**ADDENDUM
NO. 4**

October 18, 2024

**Whiteland High School Ph 2: Café Kitchen Band Choir Auditorium
300 E. Main Street
Whiteland, IN 46184**

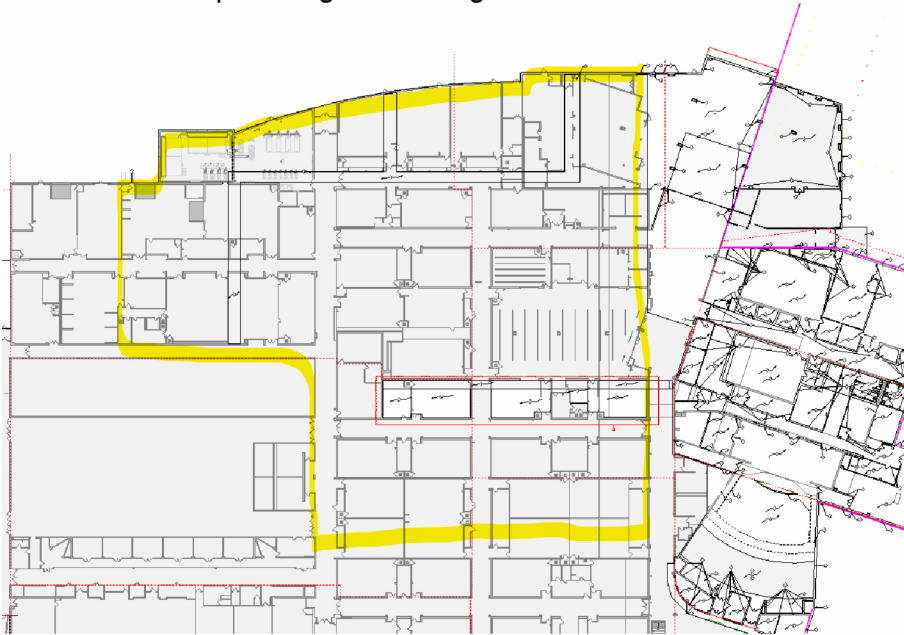
Q: What is the wall composition of knee walls inside the auditorium box?

A: Refer to typical auditorium half height wall 2/A732

SITE LAYOUT PLAN - PHASE 2

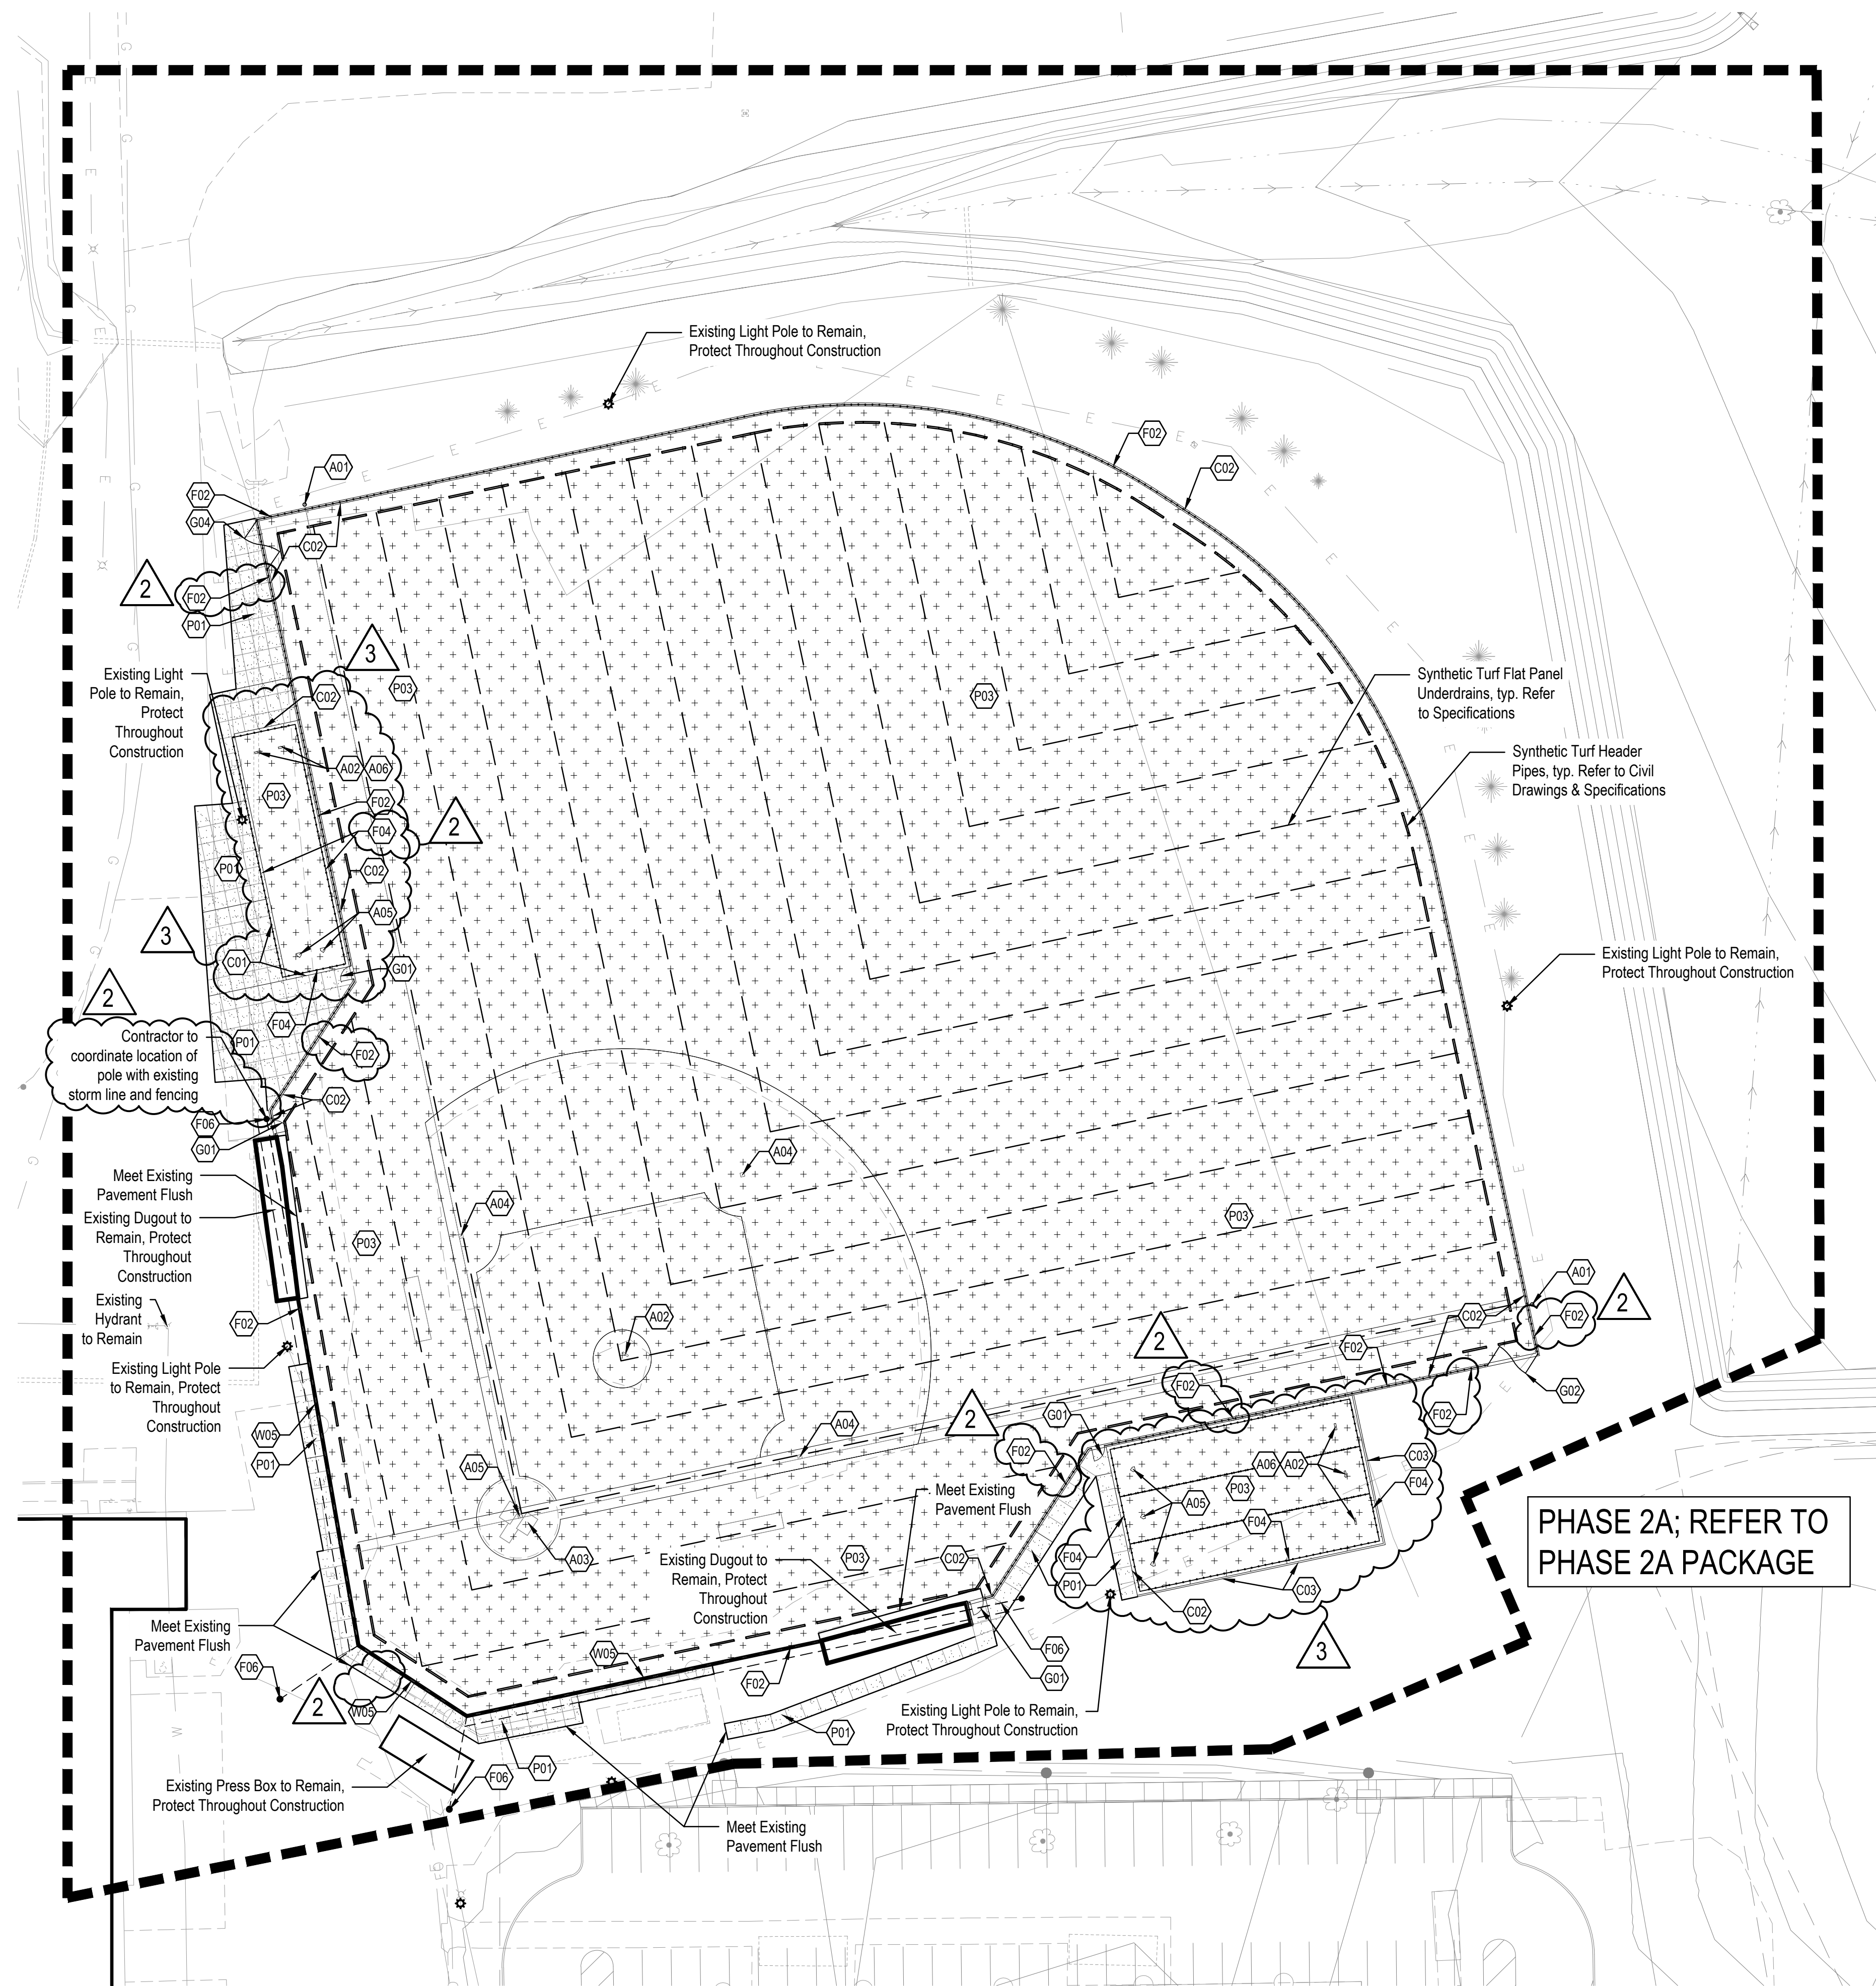
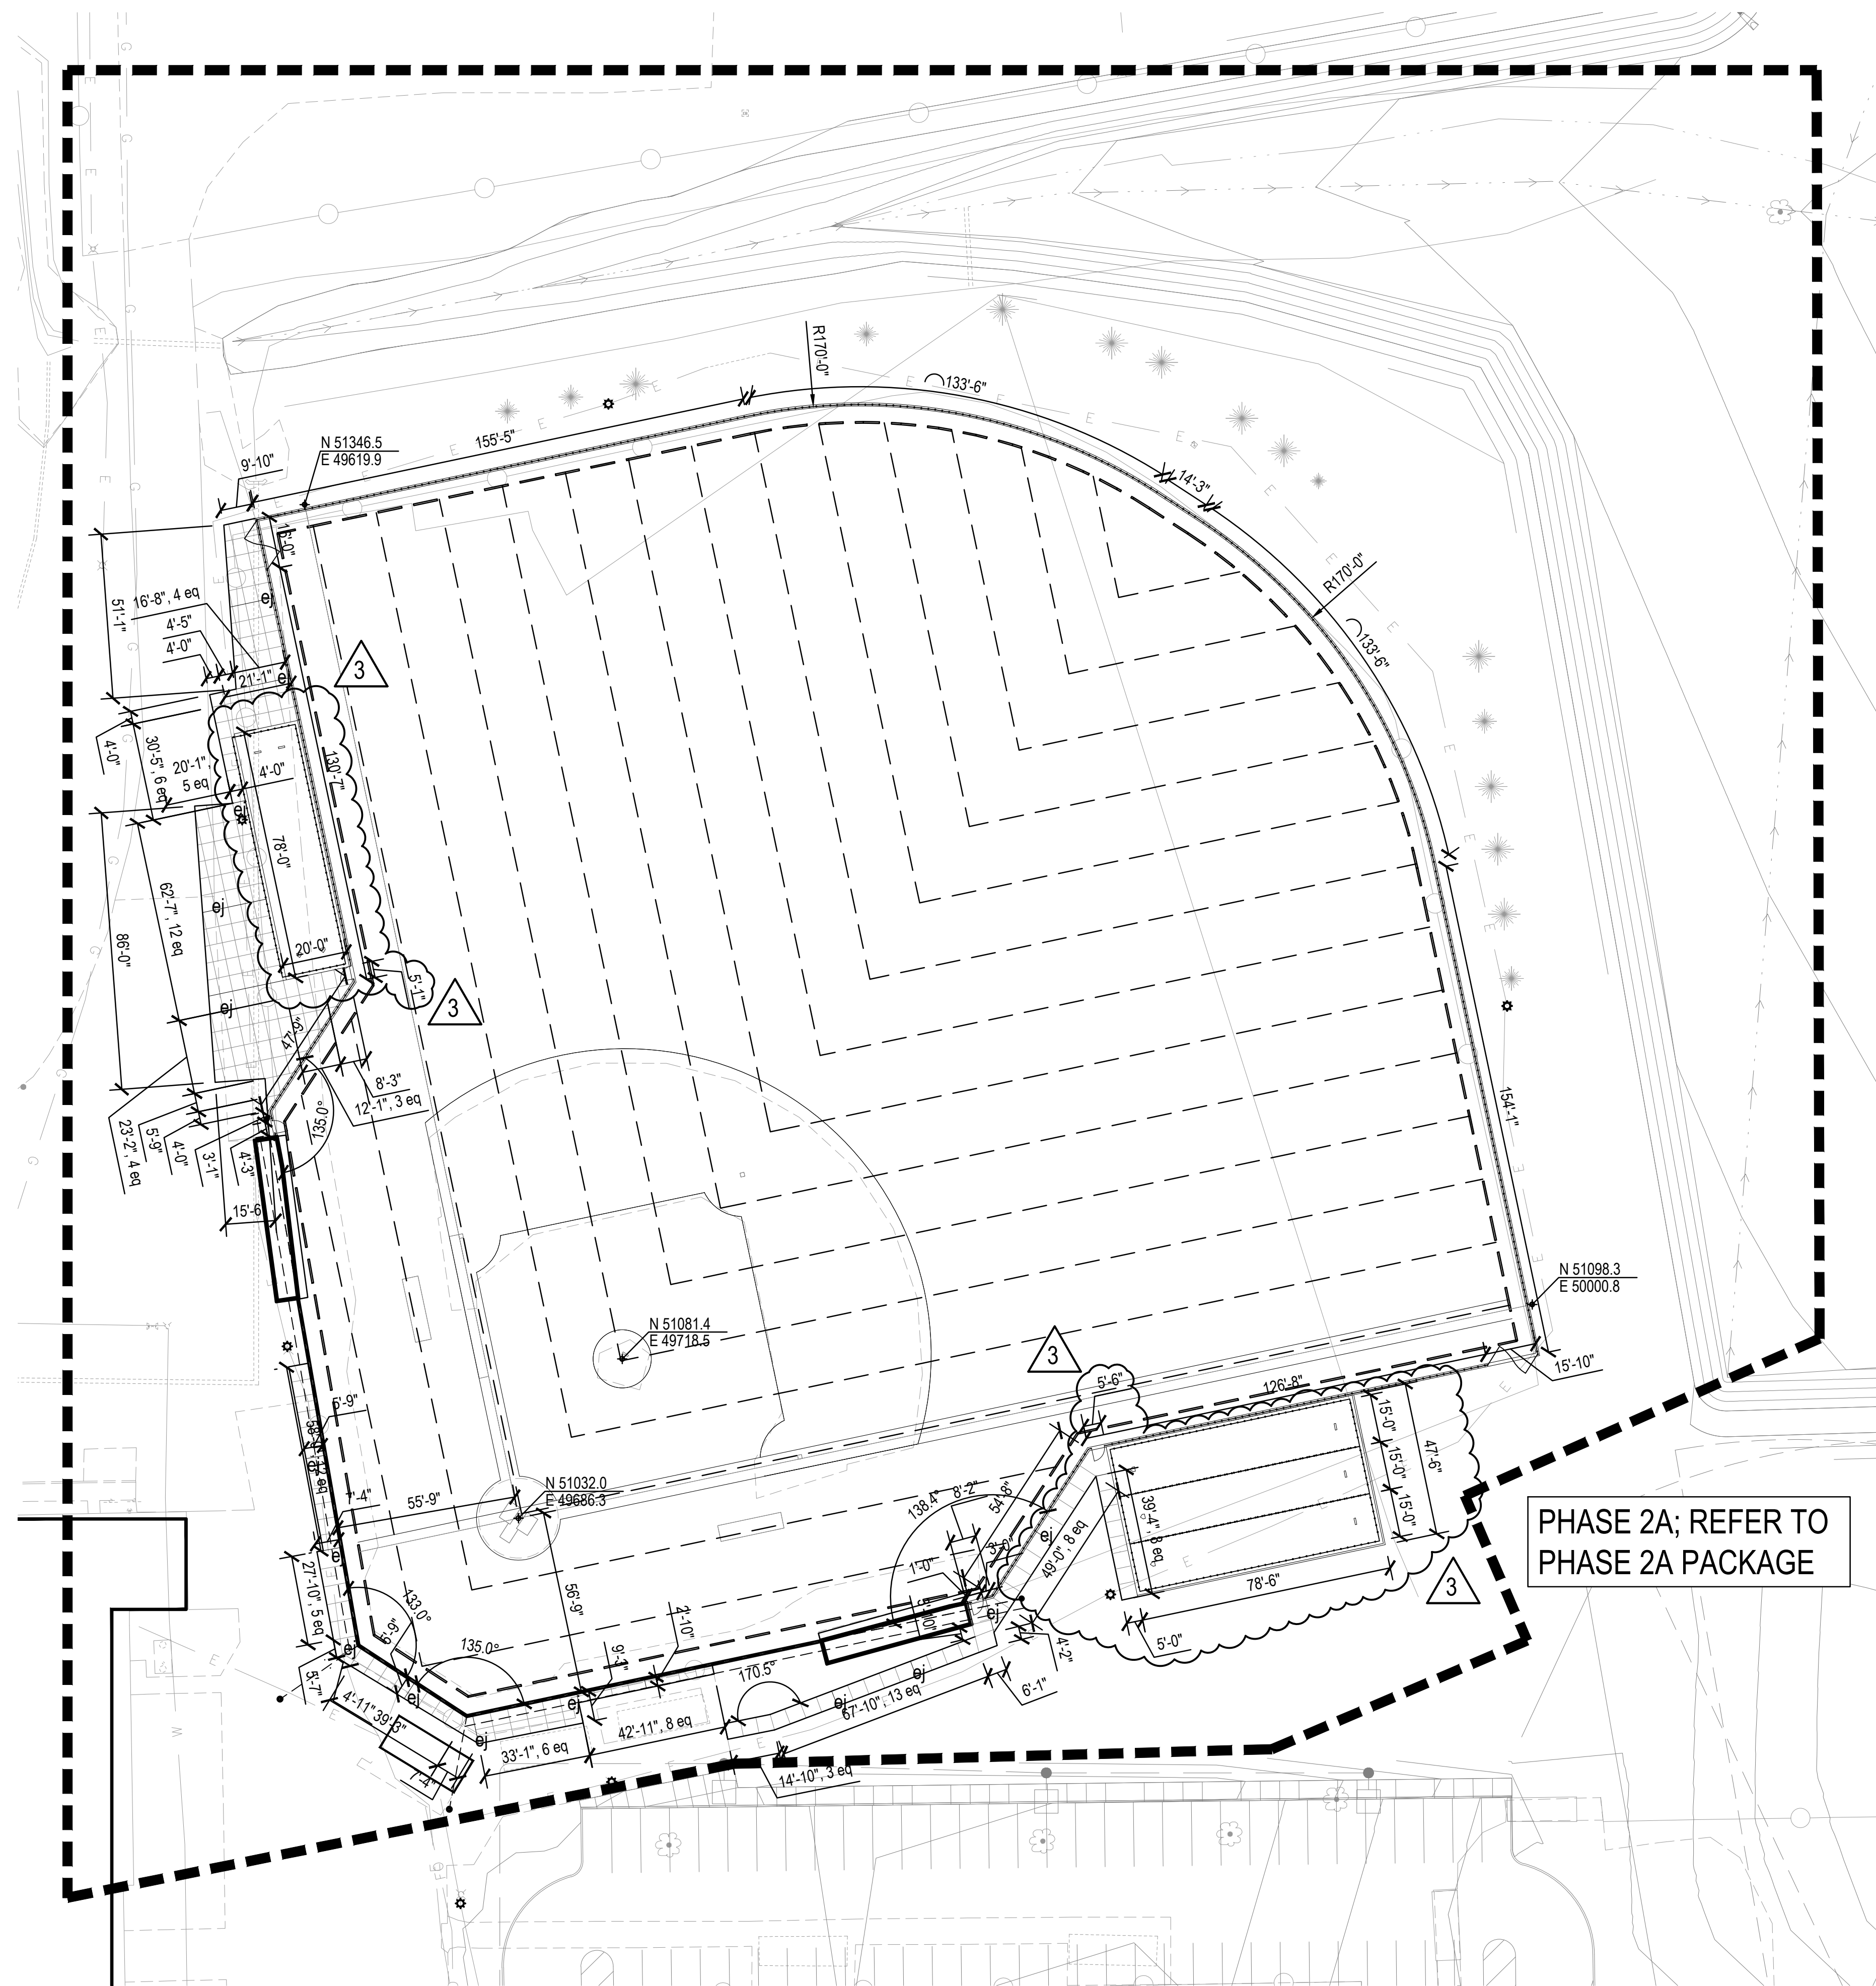
1. SHEET NUMBER : L103 SITE MATERIALS PLAN – PHASE 2

- i. Sizes of batting cage sizes revised to 70' in length.
- ii. Curbing around batting cages modified to align with new net support pole configuration.
- iii. Sidewalks adjacent to batting cages revised.
